# ADA Curb Ramp New Construction Inspection Form (Parallel)

309th North-South Road Name 24952.54 Project No. Sheet No. Intersection No. Yorkshire East-West Road Name

PARALLEL RAMP (PL)

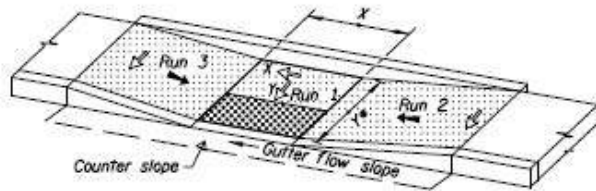
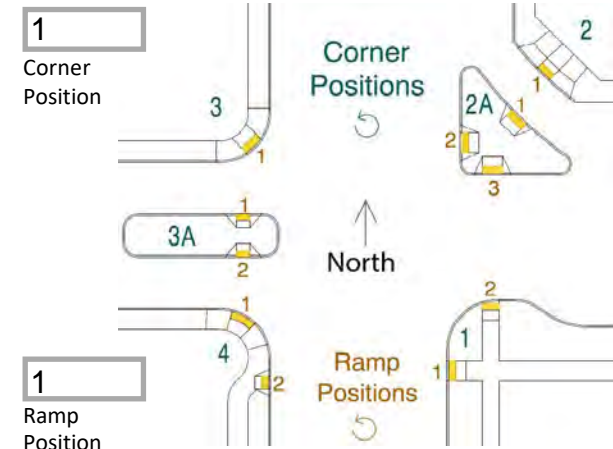
RAMP RUN 1	Pass	Fail
Running Slope 1	<input type="text" value="5.36"/> $\leq 2.0\%$ <input type="checkbox"/> $> 2.0\%$ <input type="checkbox"/>	<input type="checkbox"/>
Cross Slope 1	<input type="text" value="10.7"/> $\leq 2.0\%$ <input type="checkbox"/> $> 2.0\%$ <input type="checkbox"/>	<input type="checkbox"/>
Detectable Warning	<input type="text" value="N"/> Y <input type="checkbox"/> N <input checked="" type="checkbox"/>	<input type="checkbox"/>
Lip Height	<input type="text" value="0"/> $\leq 1/4"$ <input checked="" type="checkbox"/> $> 1/4"$ <input type="checkbox"/>	<input type="checkbox"/>
Gutter Flow Slope	<input type="text" value="10.7"/> $\leq *$ <input type="checkbox"/> $> *$ <input checked="" type="checkbox"/>	<input type="checkbox"/>
Curb Running Slope (avg)	<input type="checkbox"/> <input type="text" value="5.36"/> $\leq 8.3\%$ <input checked="" type="checkbox"/> $> 8.3\%$ <input type="checkbox"/>	<input type="checkbox"/>

Counter Slope (+/-)*2	<input type="text" value="7.5"/> $\leq  5.0\% $ <input checked="" type="checkbox"/> $>  5.0\% $ <input type="checkbox"/>	<input type="checkbox"/>
Det. warning full width of ramp	<input type="text" value="N"/> Y <input type="checkbox"/> N <input checked="" type="checkbox"/>	<input type="checkbox"/>

RAMP RUN 2	Pass	Fail
Running Slope 2	<input type="text" value="8.6"/> $\leq 8.3\%$ <input type="checkbox"/> $> 8.3\%$ <input checked="" type="checkbox"/>	<input type="checkbox"/>
Length 2	<input type="text" value="1.4"/> $\leq 2.0\%$ <input checked="" type="checkbox"/> $> 2.0\%$ <input type="checkbox"/>	<input type="checkbox"/>
Cross Slope 2	<input type="text" value="1.4"/> $\leq 2.0\%$ <input checked="" type="checkbox"/> $> 2.0\%$ <input type="checkbox"/>	<input type="checkbox"/>

RAMP RUN 3	Pass	Fail
Running Slope 3	<input type="text" value="20.8"/> $\leq 8.3\%$ <input type="checkbox"/> $> 8.3\%$ <input checked="" type="checkbox"/>	<input type="checkbox"/>
Length 3	<input type="text" value="20.8"/> $\leq 2.0\%$ <input type="checkbox"/> $> 2.0\%$ <input type="checkbox"/>	<input type="checkbox"/>
Cross Slope 3	<input type="text" value="20.8"/> $\leq 2.0\%$ <input type="checkbox"/> $> 2.0\%$ <input type="checkbox"/>	<input type="checkbox"/>

TURN SPACE	Pass	Fail
Width X	<input type="text" value="4.7"/> $\geq 4.0'$ <input checked="" type="checkbox"/> $< 4.0'$ <input type="checkbox"/>	<input type="checkbox"/>
Length Y	<input type="text" value="4.9"/> $\geq 4.0' * 1$ <input checked="" type="checkbox"/> $< 4.0' * 1$ <input type="checkbox"/>	<input type="checkbox"/>
Back of Ramp Obstruction (Y/N)	<input type="text" value="N"/> $\geq 5.0' * 1$ <input type="checkbox"/> $< 5.0' * 1$ <input type="checkbox"/>	<input type="checkbox"/>
Slope X (Cross Slope 1)	<input type="text" value="11.4"/> $\leq 2.0\%$ <input type="checkbox"/> $> 2.0\%$ <input checked="" type="checkbox"/>	<input type="checkbox"/>
Slope Y (Running Slope 1)	<input type="text" value="11.4"/> $\leq 2.0\%$ <input type="checkbox"/> $> 2.0\%$ <input checked="" type="checkbox"/>	<input type="checkbox"/>

MISCELLANEOUS	Pass	Fail
Clear Width (feet)	<input type="text" value="4.7"/> $\geq 4.0'$ <input type="checkbox"/> $< 4.0'$ <input type="checkbox"/>	<input type="checkbox"/>
Intersection Control Type	<input type="text" value="SY"/> Slope of Rd. <input type="text" value="11.0"/>	<input type="checkbox"/>
Horizontal Gaps	<input type="text" value="0"/> $\leq 1/2"$ <input checked="" type="checkbox"/> $> 1/2"$ <input type="checkbox"/>	<input type="checkbox"/>

Comments:  
No td
